UNITED STATES PATENT AND TRADEMARK OFFICE

| APPLICATION NO. | FILING DATE | FIRST NAMED INVENTOR | ATTORNEY DOCKET NO. | CONFIRMATION NO. |
|-----------------|-------------|----------------------|---------------------|------------------|
| 10/510,351 | 10/06/2004 | Ernest R. Bodnar | 1120U106 | 9530 |

DETAILED ACTION

Title : STEEL STUD WITH OPENINGS AND EDGE FORMATIONS
AND METHOD

Bodnar '625

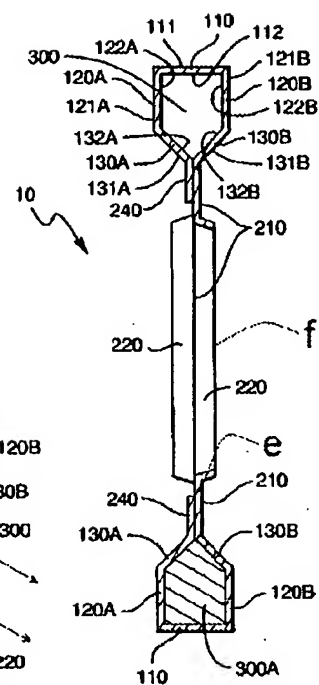
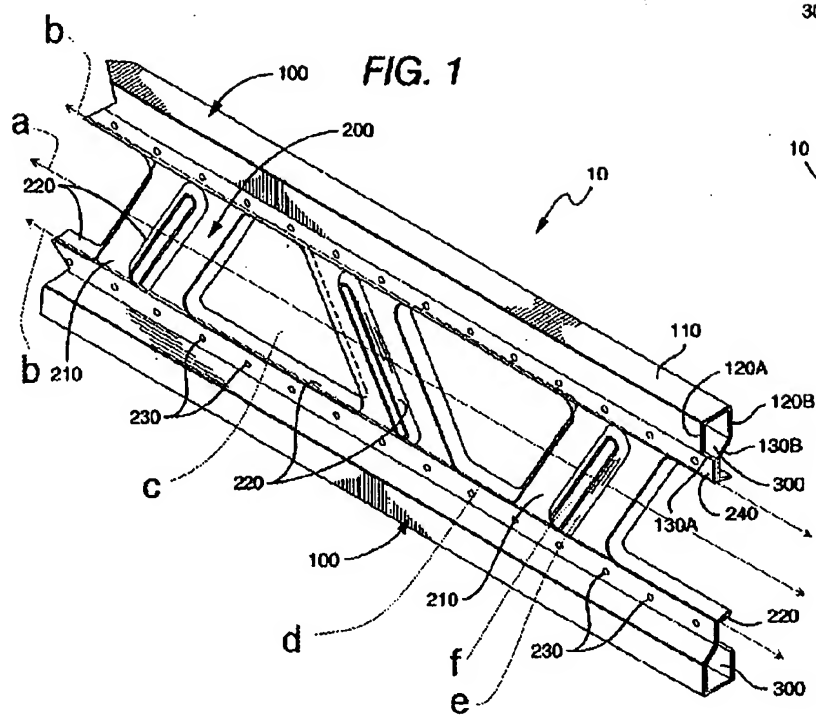
Regarding claim 1, Bodnar '625 in Figures 24-25 discloses a steel member for use in supporting structures and having reduced heat transfer characteristics as compared with solid web studs, and characterized by a web (a) defining side edges and an axis (c); a flange (312) on at least one side edge; openings (302) through said web at spaced intervals therealong, of predetermined size and profile, at least a side portion (304, 306) of said web being removed from said opening and remaining attached integrally to said web, and being bent away from said web along axes (d) parallel to said web axis (c).

Regarding claim 3, Bodnar '625 discloses the structure discussed above and further discloses that said side portion (304, 306) defines a channel shape (e) extending along an axis parallel to said web axis.

Regarding claim 4, Bodnar '625 discloses the structure discussed above and further discloses that said openings (302) are of a shape defining a linear side edge (f), and an arcuate side edge (g), said side portion (304, 306) of said web being integral with said linear side edge (f).

Regarding claim 5, Bodnar '625 discloses the structure discussed above and further discloses that there are two said flanges (312) one on each side of said web, being formed at normal to said web, and lips (h) formed along said flanges and normal to said flanges.

Regarding claim 6, Bodnar '625 discloses the structure discussed above and further discloses that openings (302) are arranged in an alternating orientation and struts (308) are defined between said openings, said struts extending diagonally across said member.

Regarding claim 26, Bodnar '625 in Figures 24-25 discloses a steel member having a web (a), side edges, and a flange (312) along at least one said side edge and openings (302) through said web wherein said openings (302) are formed in said web at spaced intervals therealong, with one of said openings leaving a side portion of metal attached to said web forming an edge flange (304, 306) along said at least one side edge of said web and forming said side portion out of the plane of said web wherein said side portion is bent along bend lines (d) parallel to the web axis (c). Therefore, the method steps set forth in claim 26 of forming the steel member with the above said structure and bending side portions would have been an obvious if not inherent method of making the steel member having the same structure.

Meyer '217

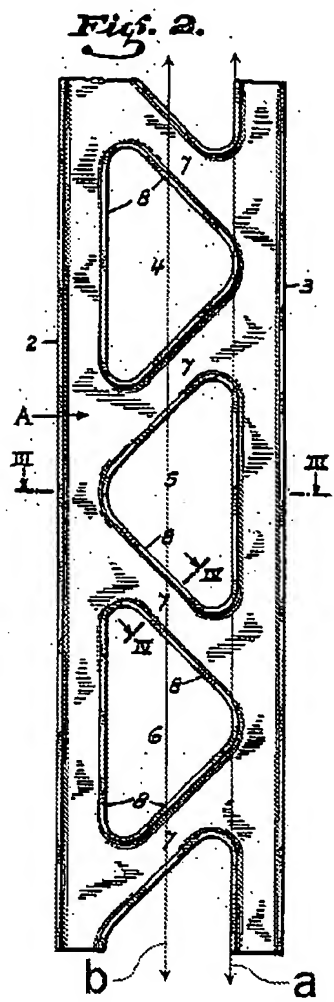
Regarding claim 1, Meyer '217 in Figures 1 and 2 discloses a steel member for use in supporting structures and having reduced heat transfer characteristics as compared with solid web studs, and characterized by a web (210) defining side edges and an axis (a); a flange (120a, 110) on at least one side edge; openings (c) through said web at spaced intervals therealong, of predetermined size and profile, at least a side portion (d, 220) of said web being removed from said opening and remaining attached integrally to said web, and being bent away from said web along axes (b) parallel to said web axis (a).

Regarding claim 2, Meyer '217 discloses the structure discussed above and further discloses depressions (e) formed in said web at spaced intervals, and an opening (f) formed in said depressions to reduce heat transfer.

Folsom '781

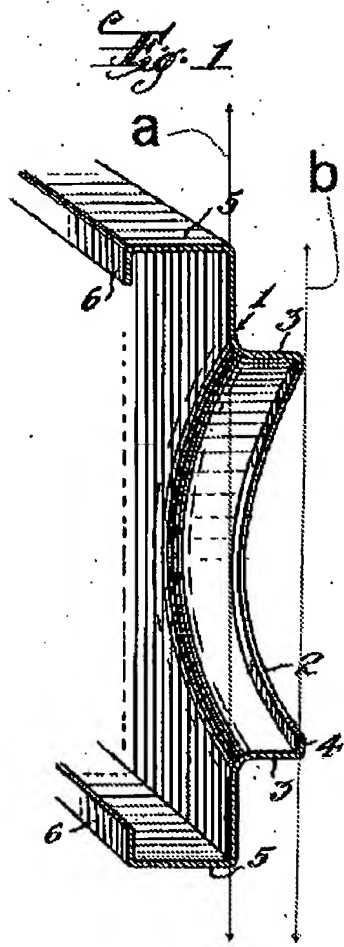
Regarding claim 1, Folsom '781 in Figures 1 and 2 discloses a metal member for use in supporting structures and having reduced heat transfer characteristics as

compared with solid web studs, and characterized by a web (A) defining side edges and an axis (b); a flange (3) on at least one side edge; openings (4-6) through said web at spaced intervals therealong, of predetermined size and profile, at least a side portion (8) of said web being removed from said opening and remaining attached integrally to said web, and being bent away from said web along axes (a) parallel to said web axis (b), but does not disclose that the member is steel. However, it would have been obvious to one having ordinary skill in the art at the time of invention to use steel, since it has been held to be within the general skill of a worker in the art to select a known material on the basis of its suitability for the intended use as a matter of obvious design choice. *In re Leshin*, 227 F.2d 197, 125 USPQ 416 (CCPA 1960)

Regarding claim 6, Folsom '781 discloses the structure discussed above and further discloses that said openings (406) are arranged in an alternating orientation and struts (7) are defined between said openings, said struts extending diagonally across said member.

Regarding claim 26, Folsom '781 discloses a steel member having a web (A), side edges, and a flange (3) along at least one said side edge and openings (4-6) through said web wherein said openings (4-6) are formed in said web at spaced intervals therealong, with one of said openings leaving a side portion of metal attached to said web forming an edge flange (8) along said at least one side edge of said web and forming said side portion out of the plane of said web wherein said side portion is bent along bend lines (a) parallel to the web axis (b). Therefore, the method steps set forth in claim 26 of forming the steel member with the above said structure and bending
